#### ADDENDUM NO. 2

# Spartanburg Community College Evans Building Nursing Relocation GMC # ACST240005

131 Community College Drive Spartanburg, SC 29303 September 24, 2024

RAILING DETAILS

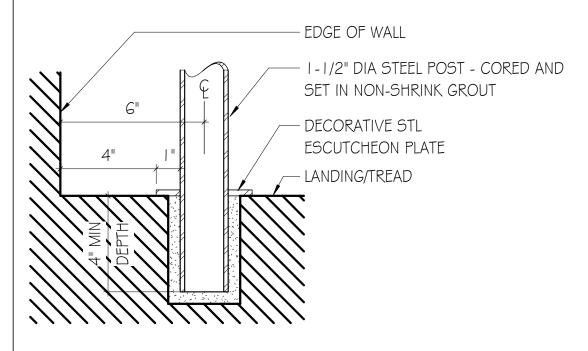
# Railing Details

1. See Attached Sketch AD-1.7

1) Fire Protection Plan
1/16" = 1'-0"

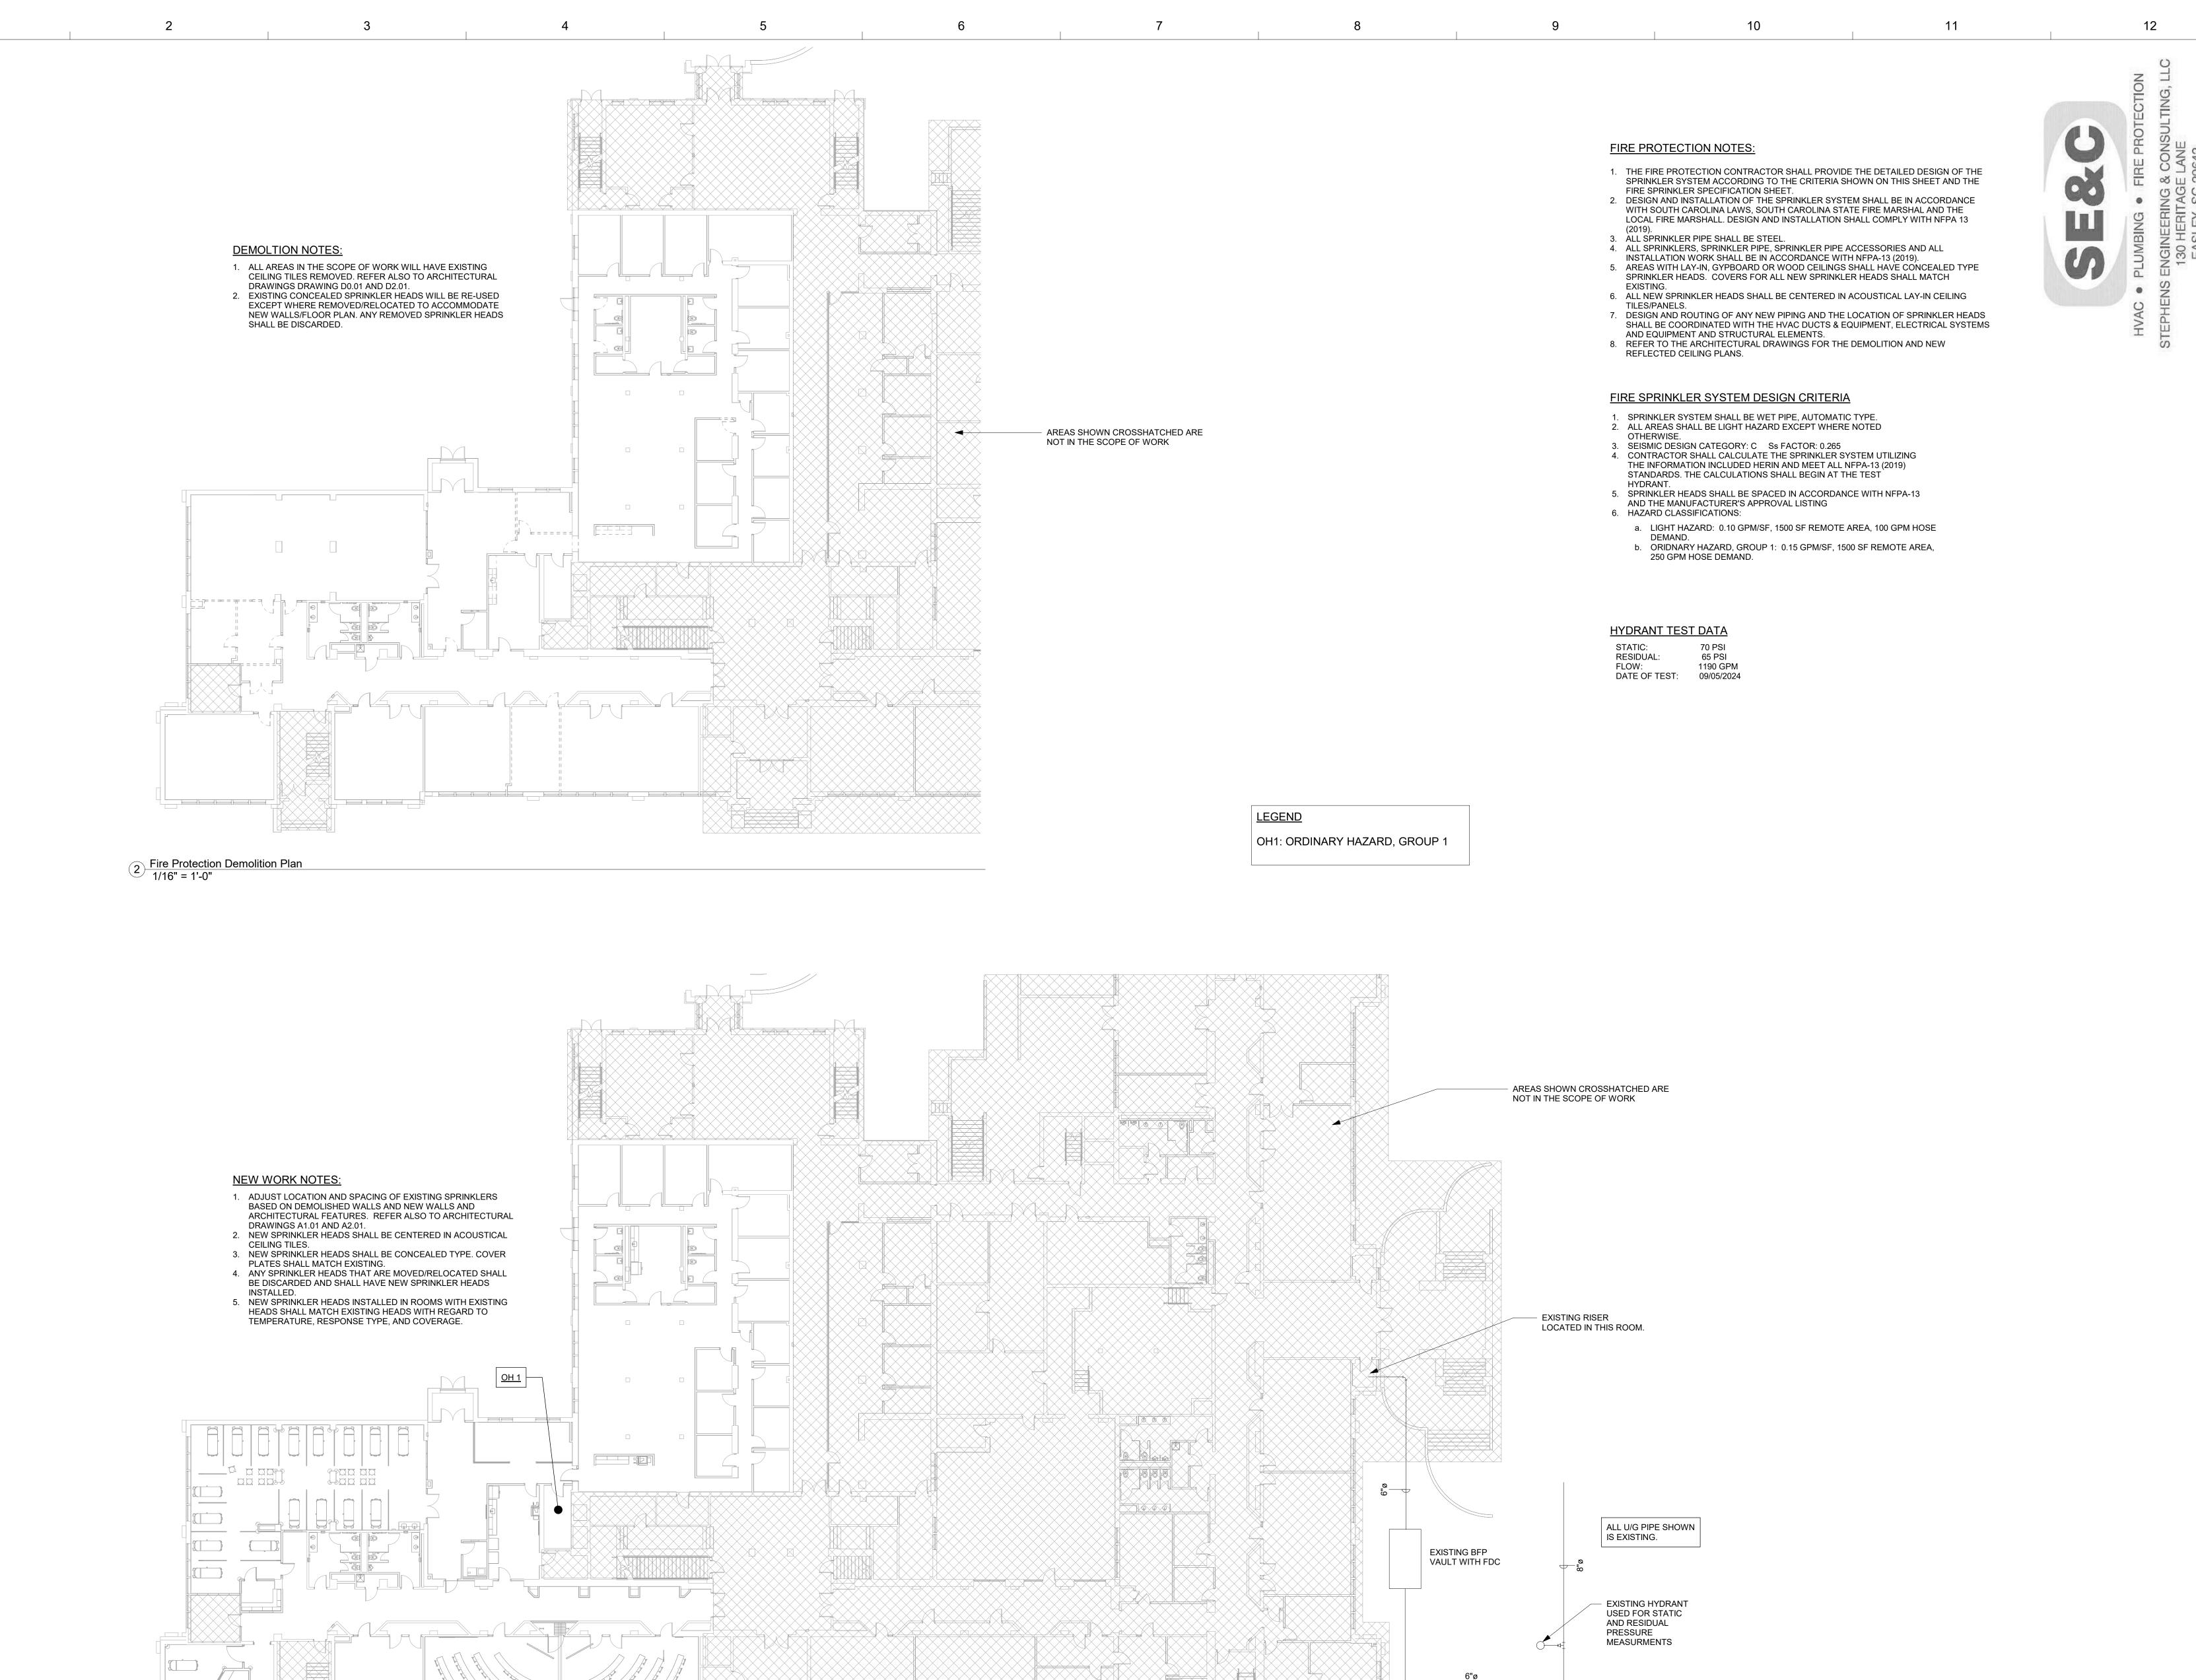
# FP1.01 Fire Sprinkler Plans

1. Attached is the new Fire Sprinkler Plan for the project.
